Addendum No. 2

PROJECT: SWIMMING POOL BUILDING MASONRY RESTORATION AT LYNDBURST

DATE: MARCH 17, 2026

RE: ADDENDUM NO. 2 TO REQUEST FOR PROPOSALS, ISSUED FEBRUARY 12, 2026

A-101

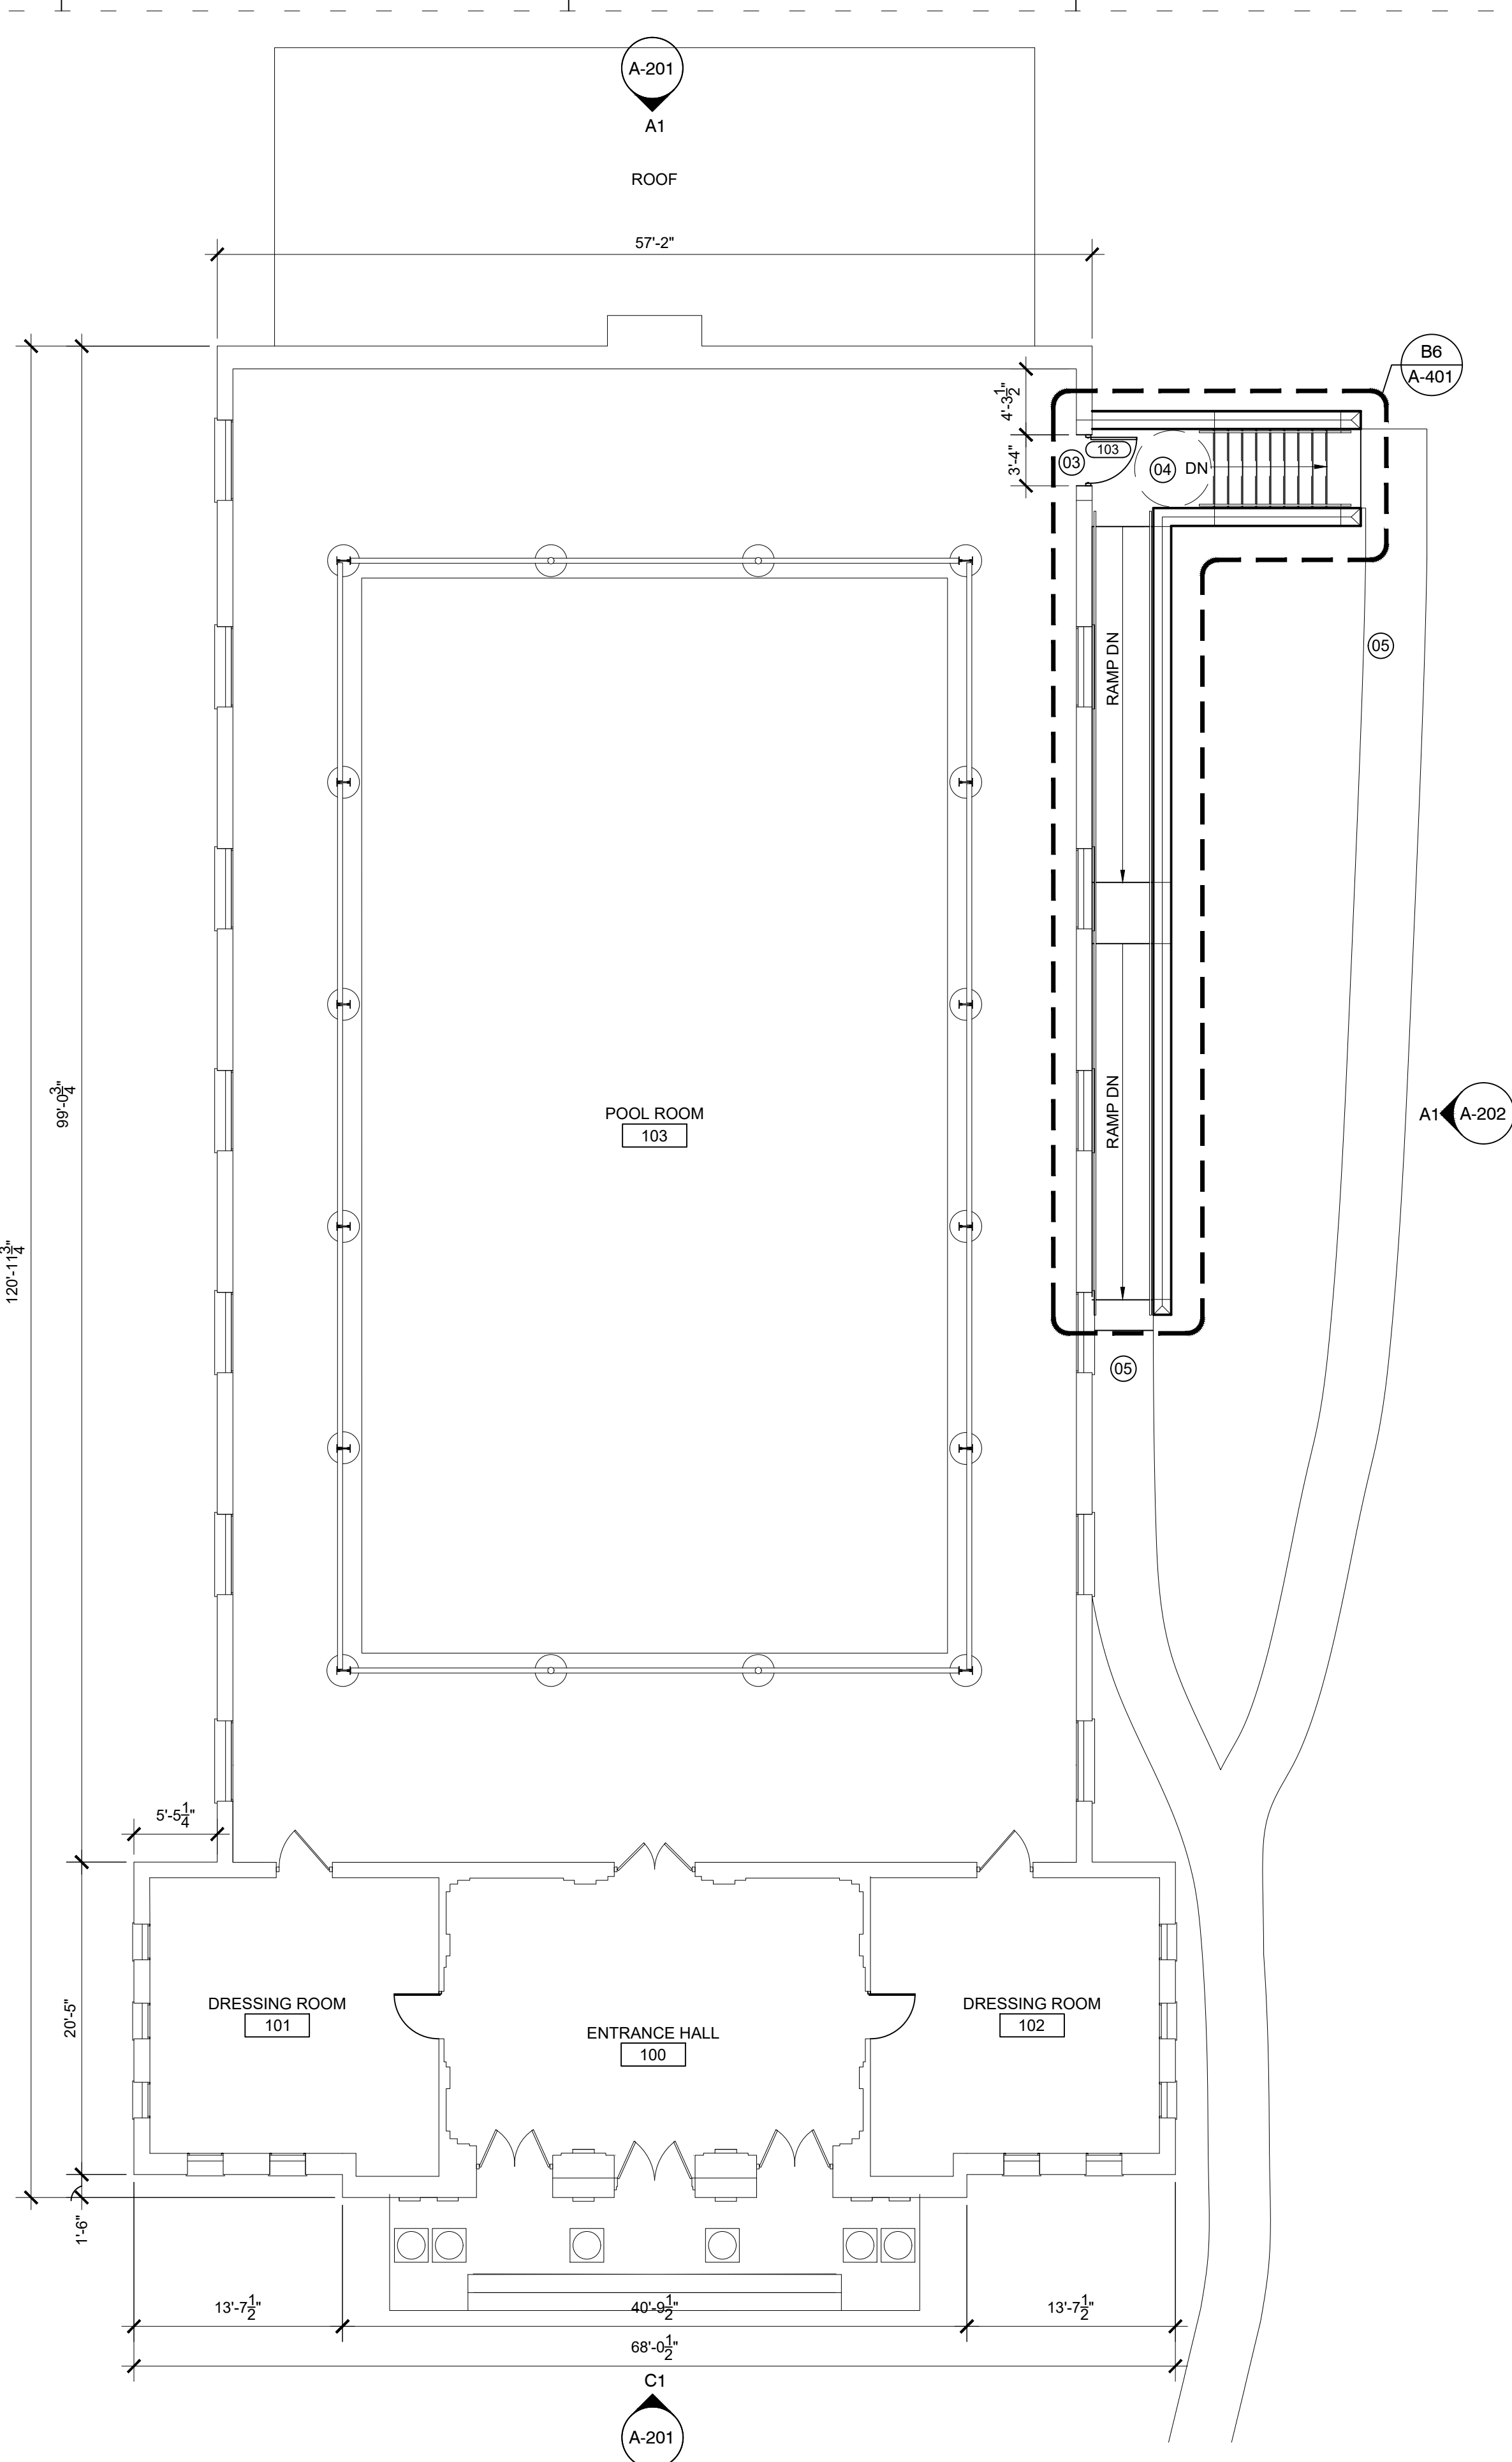
1. SHEET A-101 FLOOR PLANS
 - a. Revise PLAN KEYNOTES as noted. New HM Door and Ramp/Stair assembly are now Alternate A-1.
2. SHEET A-401 ENLARGED PLAN AND ELEVATIONS - ADA RAMP AND STAIRS
 - a. Revise sheet as noted.
3. SHEET A-501
 - a. Issue sheet in its entirety.

- 01 NOT USED
- 02 NOT USED
- 03 NEW HM DOOR AND FRAME IN NEW MASONRY OPENING. REFER TO DOOR SCHEDULE FOR ADDITIONAL INFORMATION. SALVAGE REMOVED BRICK FOR REUSE. (ALTERNATE A-1)
- 04 NEW ADA-COMPLIANT MASONRY AND CAST-IN-PLACE CONCRETE RAMP AND STAIR ASSEMBLY WITH PAINTED METAL HANDRAILS. REFER TO ENLARGED PLAN, ELEVATIONS, AND DETAILS. (ALTERNATE A-1)
- 05 NEW CONCRETE WALKWAY, BY OTHERS (NIC).

A-401

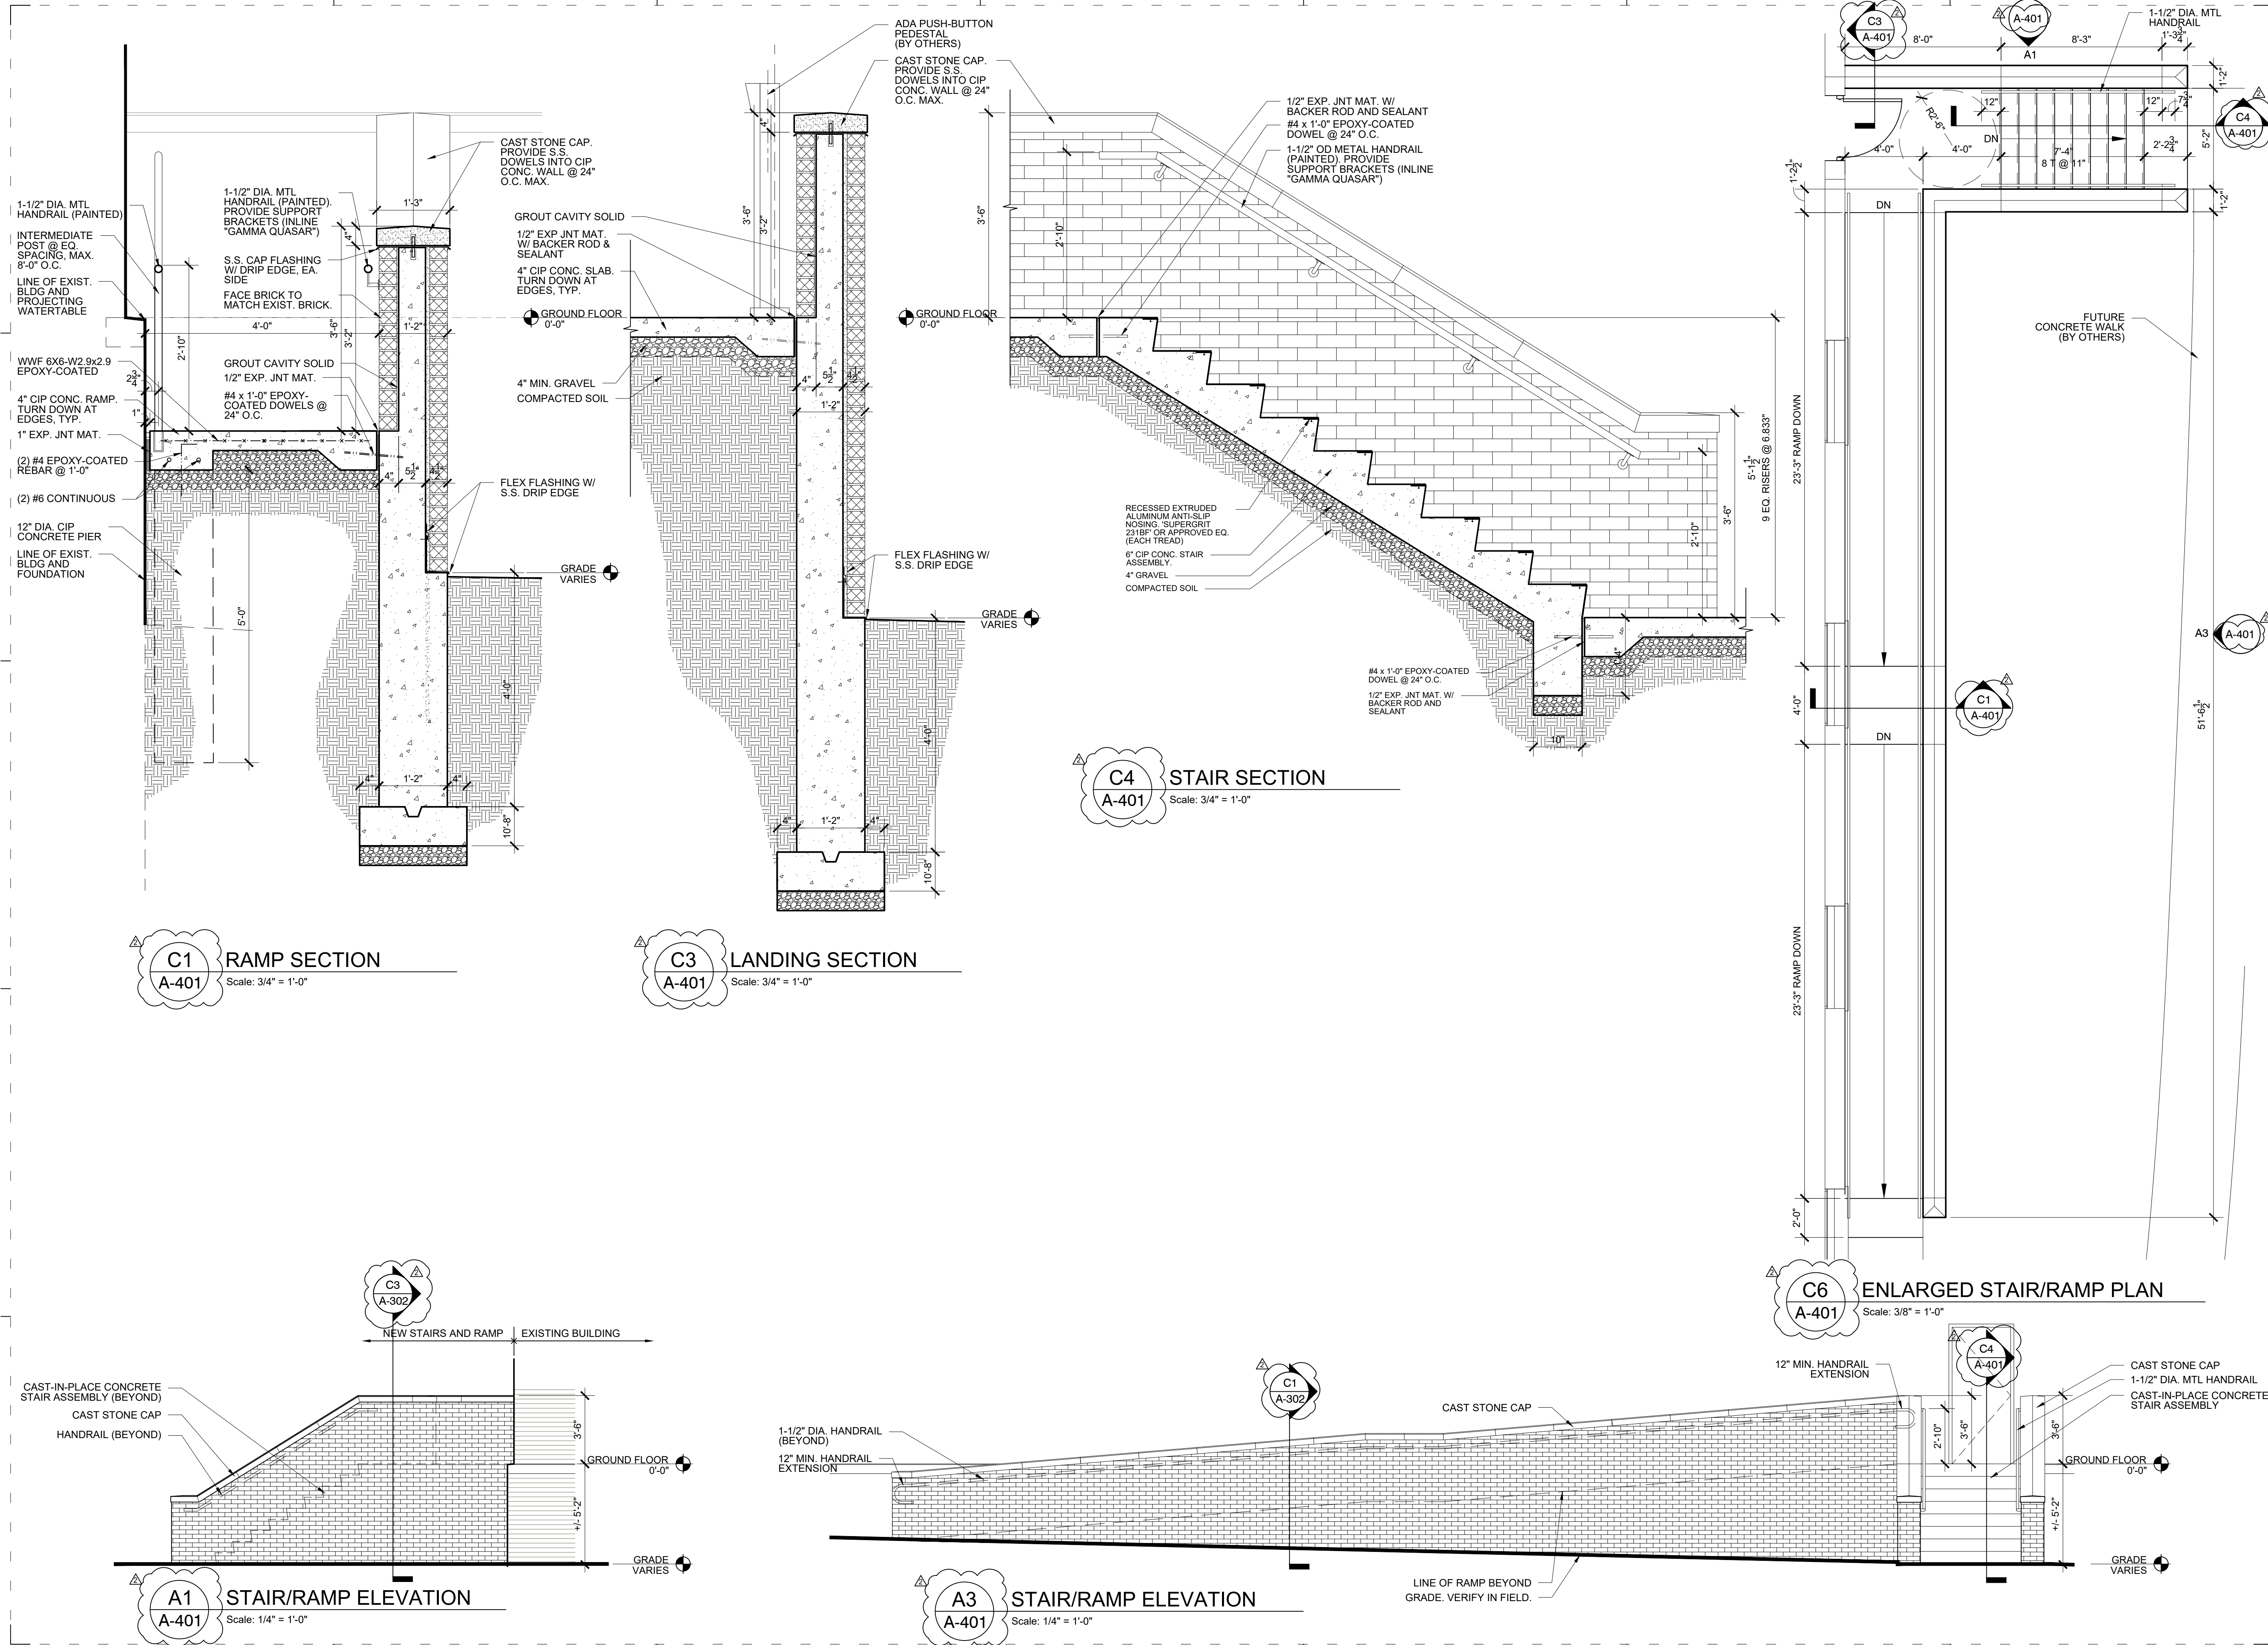
A: This was an error. There is no A-302 sheet. Detailed referring to A-302 should have referred to A-401. Refer to DRAWINGS section for revisions.

A-501

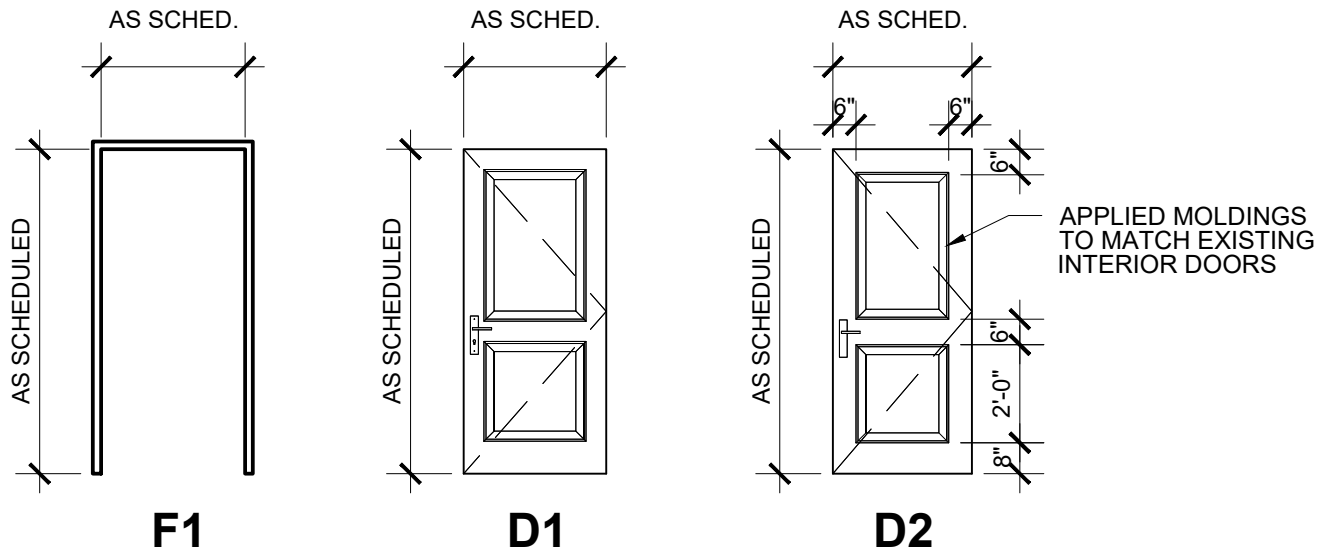
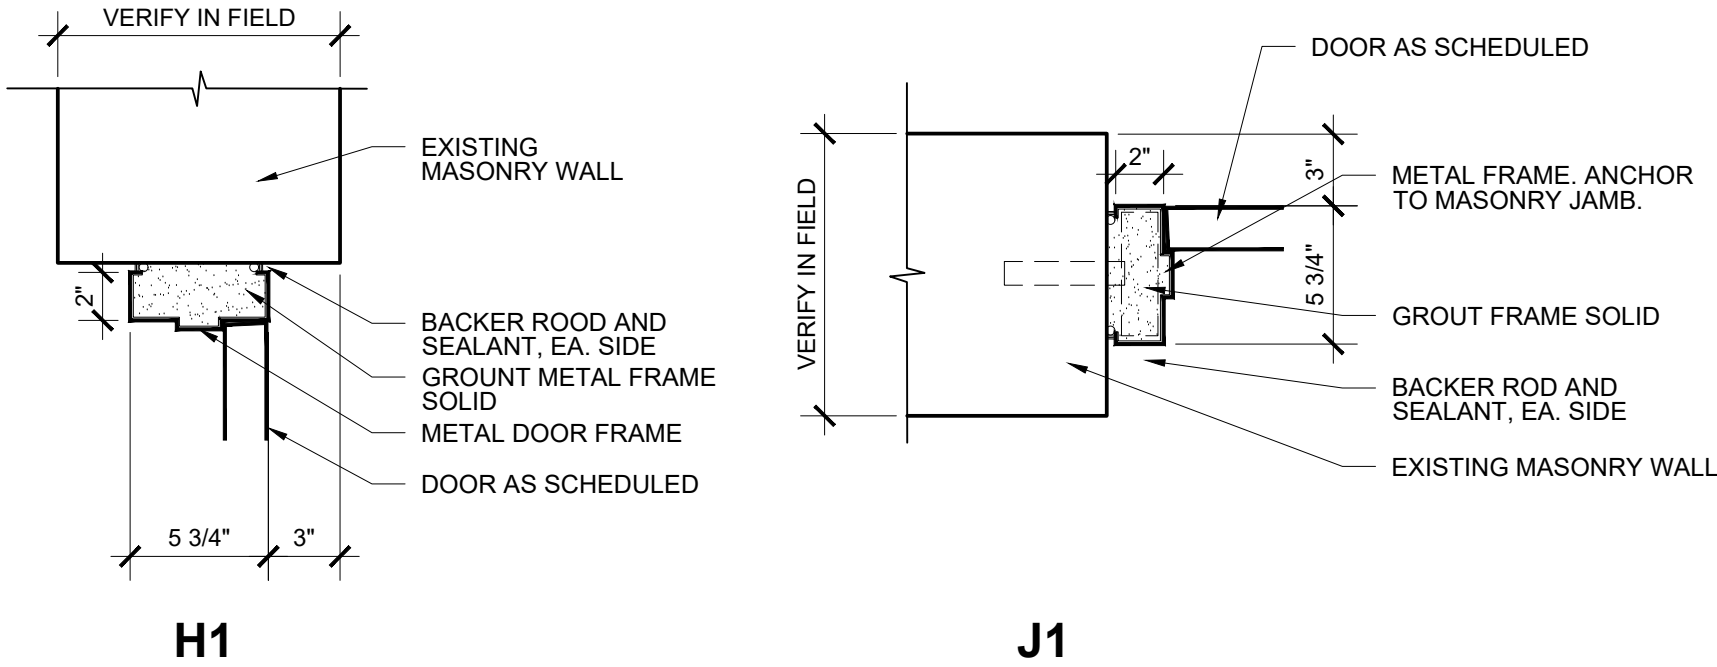
Q4: Drawing A-501 is missing from the set, please provide.

A: A-501 has been issued with Addendum 02.
